2018 Changes to International Codes

IBC - EGRESS - FIRE TAC

**2018 International Building Code (IBC – Egress)
Fire TAC**

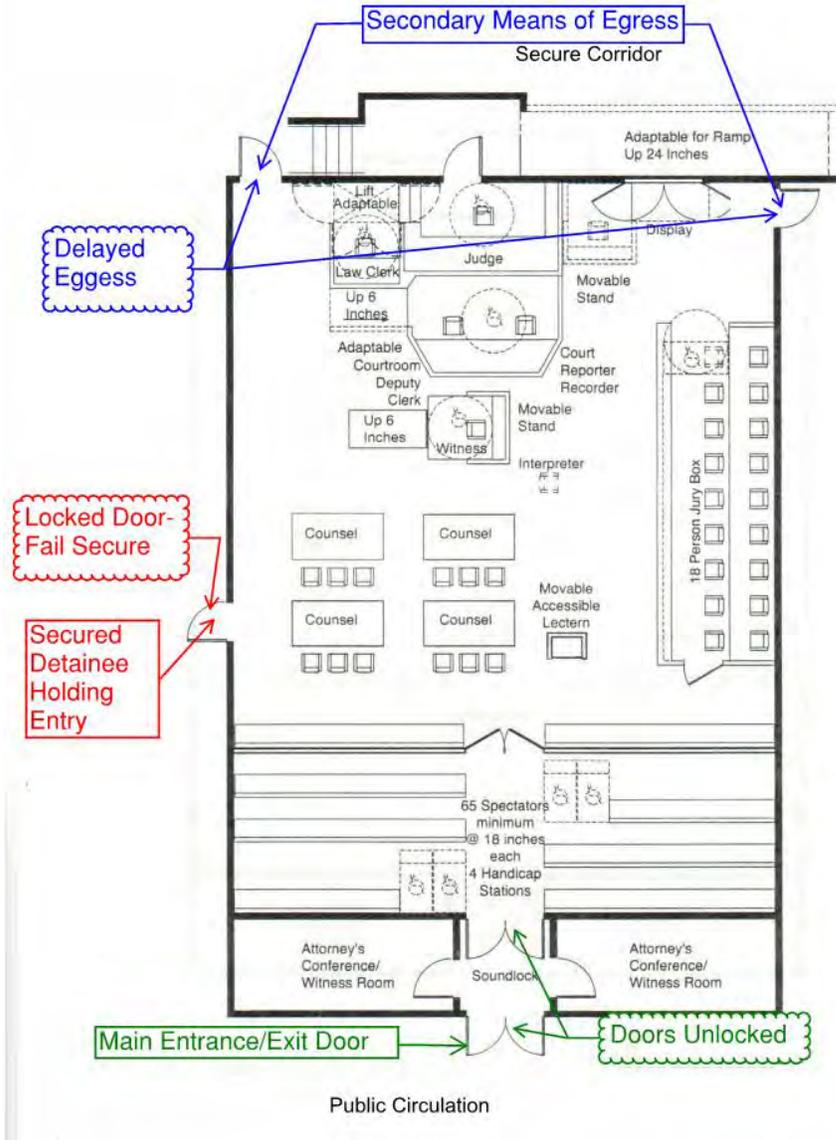
Commenter's Reason: The intent of this code change proposal is to permit the use of delayed egress system on door(s) other than the main entrance/exit door(s) from a courtroom. According to Chapter 3 in the IBC, courtrooms are considered Assembly occupancies. Therefore, delayed egress locking systems would not be permitted to be installed on any doors from a courtroom. However, courtrooms are located within courthouses which are a unique building type that is designed with three separate and distinct circulation systems – one for the public, one for the judiciary/secure staff, and one for in-custody inmates. The three circulation systems are segregated and they only meet in a single location, the courtrooms. The public enter the courtroom from the public corridor, the judges and court staff enter from the secure corridor and the prisoners enter from the secure detainee area that is typically adjacent to the courtroom. Because each of these groups must be kept separate for security reasons, it is necessary to lock the doors where these groups interface to prevent intermixing.

A standard courtroom design (Please refer to diagram) provides free egress for the public from the main entrance/exit door(s) (the same entrance the public entered the courtroom) to the public circulation area. The door serving the detainee area (prisoner interface) is locked and fail secure, which is permitted by code. As stated above, since the courtrooms are considered an "assembly occupancy" and have an occupant load of 50 or more persons they require a second means of egress. Industry practice has been to utilize the exit(s) in the front of the courtroom as the secondary means of egress. These egress door(s) also serve as the entrance/egress for the judge and court staff. (Please refer to diagram). To maintain the security separation of occupants, it is industry practice to equip these second means of egress door(s) with a delayed egress locking system which prevents any unauthorized person from gaining access to the secure corridor areas.

1010.1.9.7 Delayed egress. Delayed egress locking systems shall be permitted to be installed on doors serving any occupancy except Group A, E and H in buildings that are equipped throughout with an *automatic sprinkler system* in accordance with Section 903.3.1.1 or an *approved automatic smoke or heat detection system* installed in accordance with Section 907.

Exception: Delayed egress locking systems shall be permitted to be installed on exit or exit access doors serving courtrooms within, other than the main exit or exit access door, that serve a Group A occupancies that are courtroom in buildings that are equipped throughout with an automatic sprinkler system in accordance with Section 903.3.1.1.

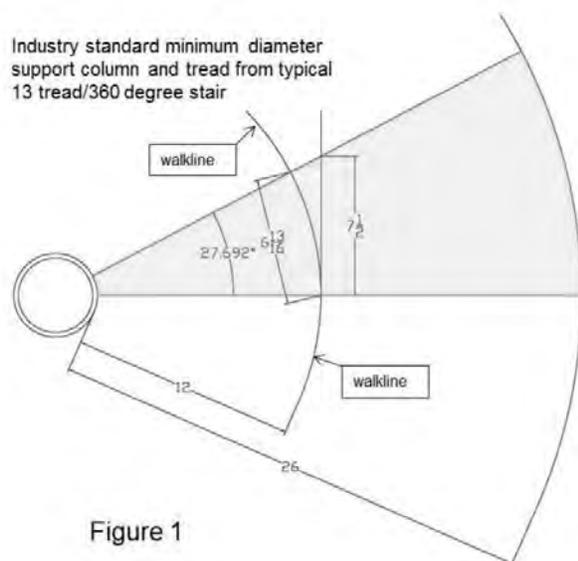
Reason: We will try again in this cycle to prevent the elimination of spiral stairways!

Winder tread depth is measured "...between the vertical planes of the foremost projection of adjacent treads at the interactions with the walkline...". The change in the method of measurement results in a smaller dimension, for the same tread, that is ³/₄ inch smaller in tread depth as illustrated in figure 1. The figure also illustrates the elements of spiral stair tread geometry. What is critical to understand is that if the code is not changed, each tread in the typical spiral stairway would need to be increased by ³/₄ inch from the longstanding accepted practice.

A *spiral stairway* shall have a ~~7¹/₂~~^{6³/₄} inch (194~~171~~) mm minimum clear tread depth at a point 12 inches (305 mm) from the ~~narrow edge~~ walkline. The risers shall be sufficient to provide a headroom of 78 inches (1981 mm) minimum, but riser height shall not be more than 9¹/₂ inches (241 mm). The minimum stairway clear width at and below the handrail shall be 26 inches (660 mm).
